ADDENDUM NO. 3

**Freedom Park Restroom/ Snack Bar Renovation Project
Spec No.FWRR.09.26.27**

July 29, 2026

1. **Added specifications for the cooling shutters**
(Attached – Exhibit A pages 5-11)
2. **Construction plan clarification markup summary (Attached -Exhibit B –**
pages 12-20)
3. **Construction plan RFI callout (Attached - Exhibit C – pages 21-32)**

1 DEMOLITION REFLECTIVE CEILING PLAN
SCALE: 1/4" = 1'-0"

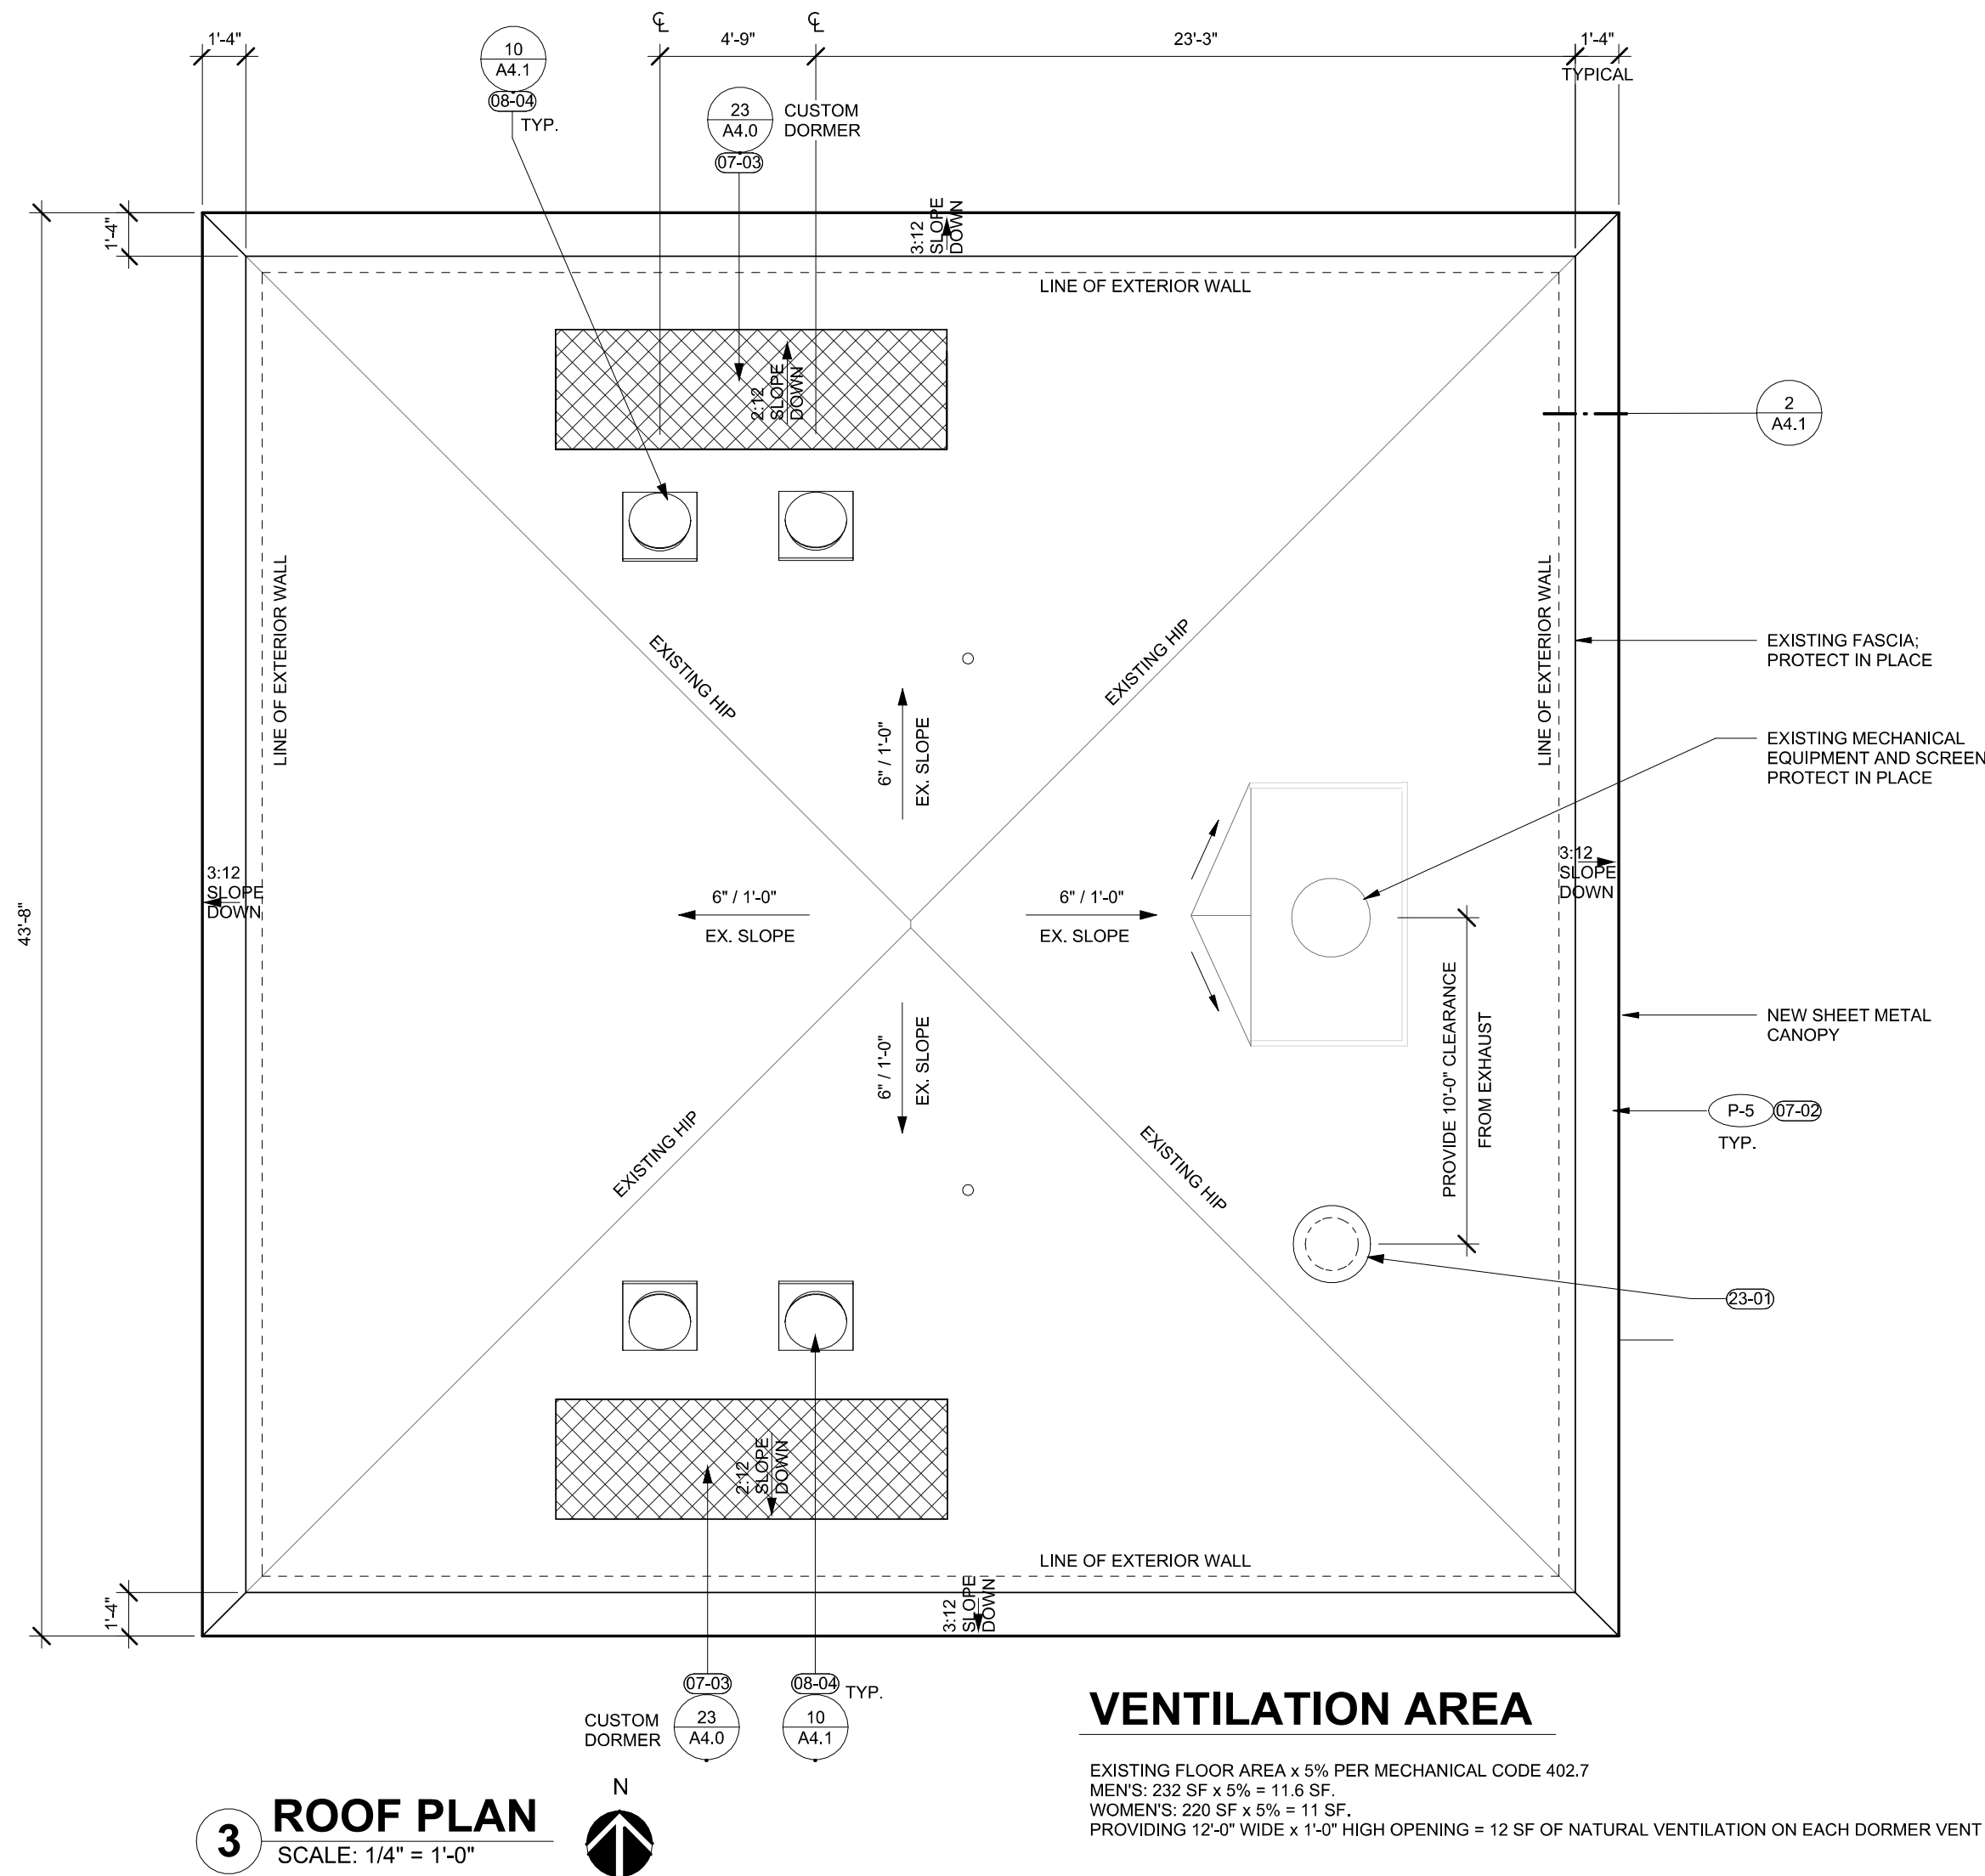
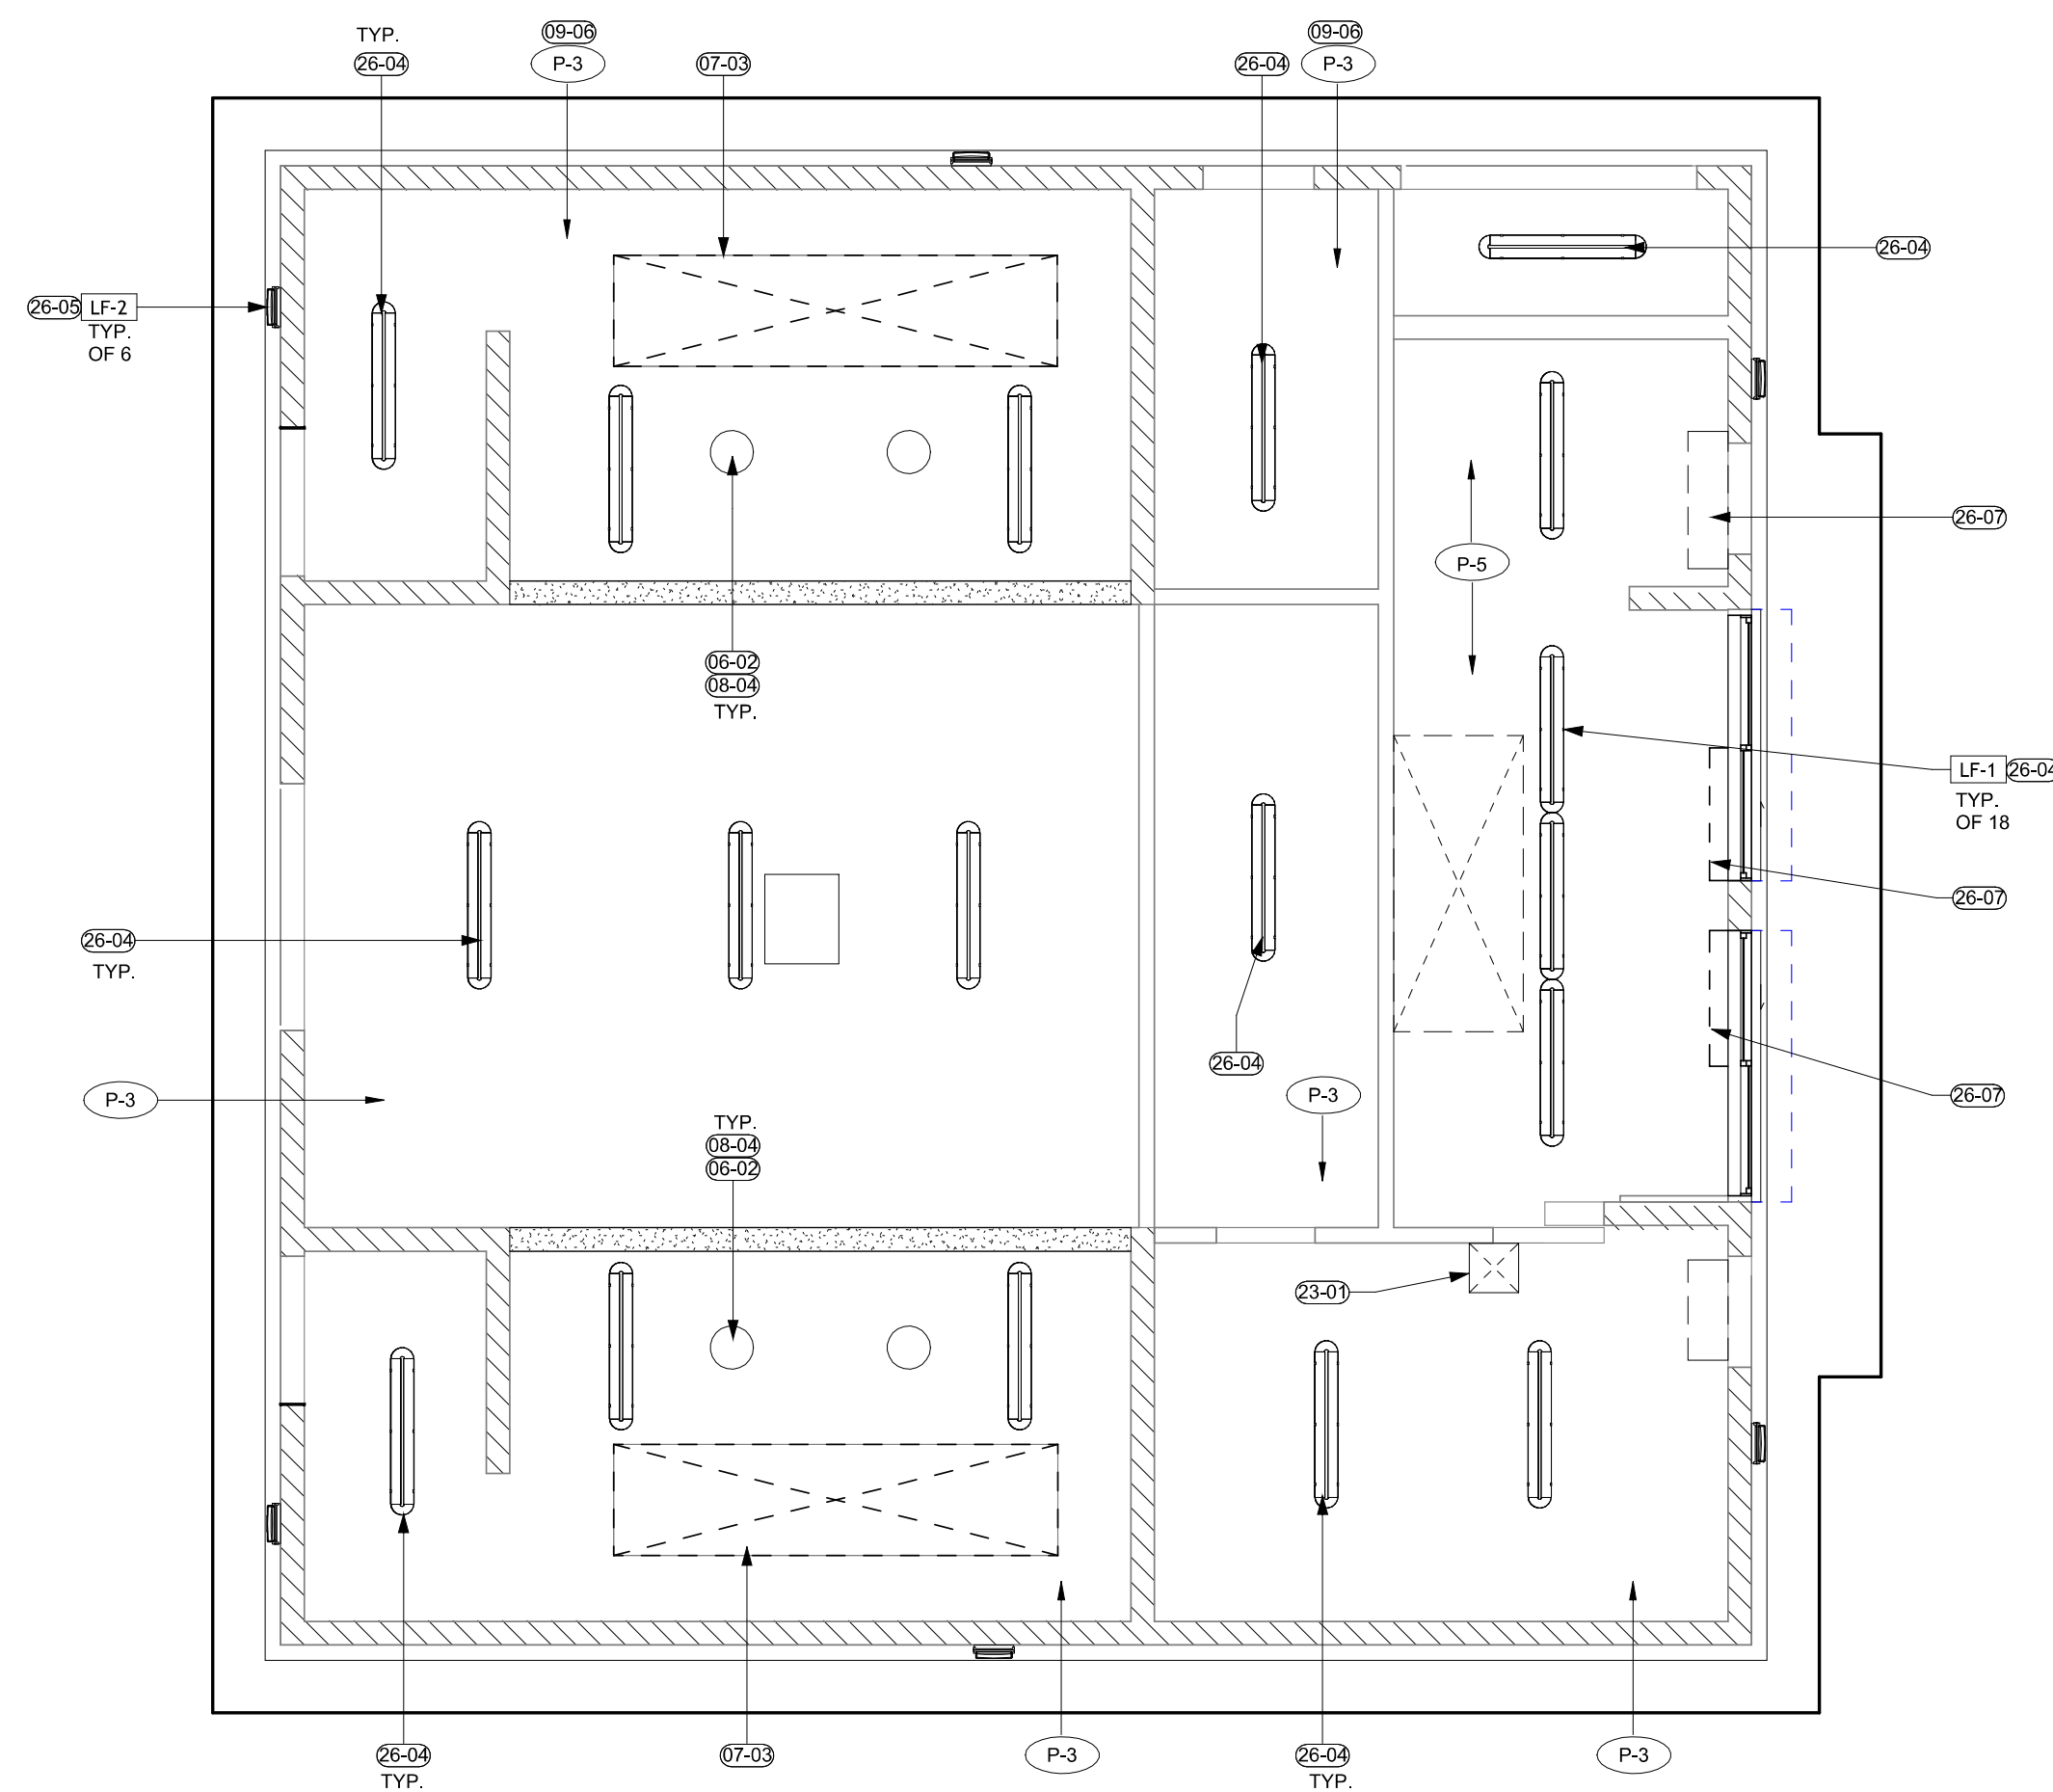
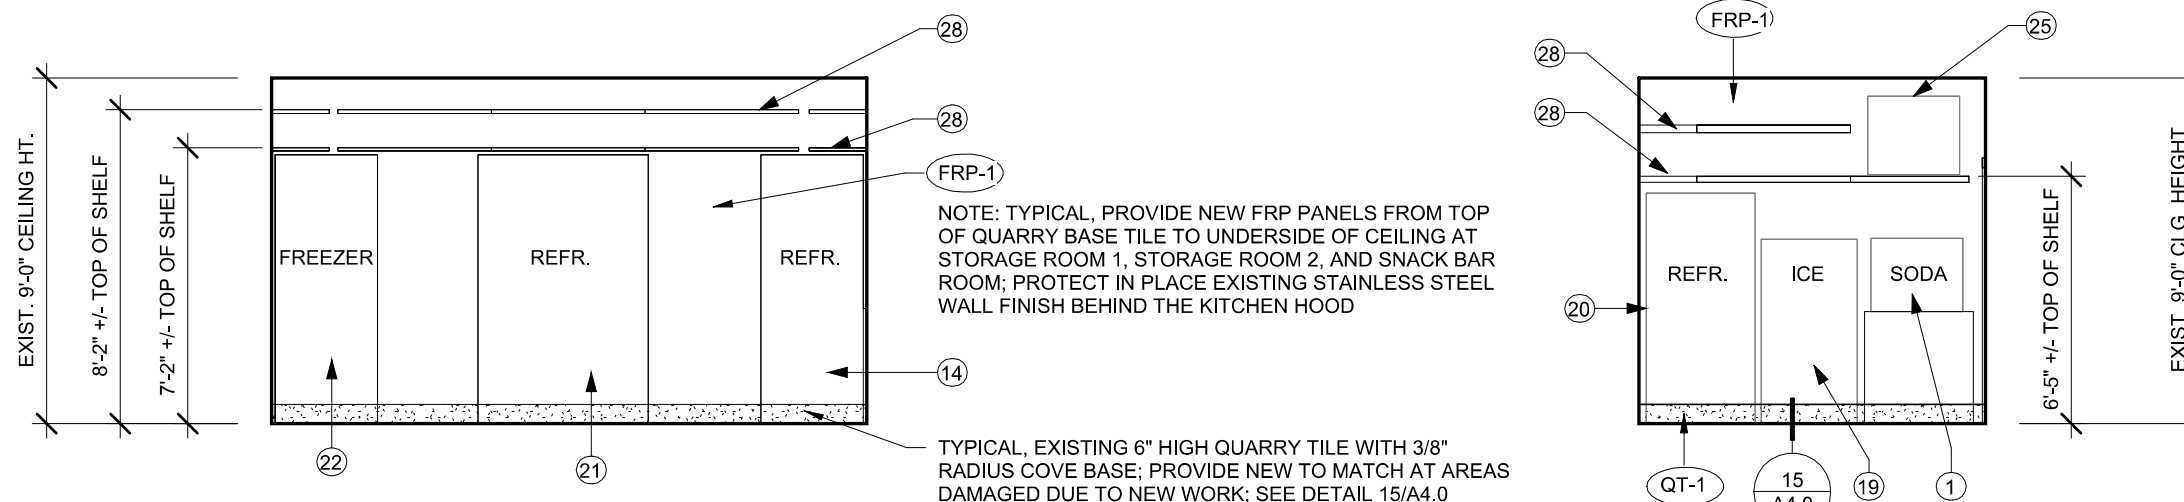
DETAILS Detail 20/A.4 indicates doors and frames to be powder coated

Detail 20/A.4 indicates doors and frames to be powder coated

See revised note on P-2 for powder coating metal gates only and to match color of P-2.
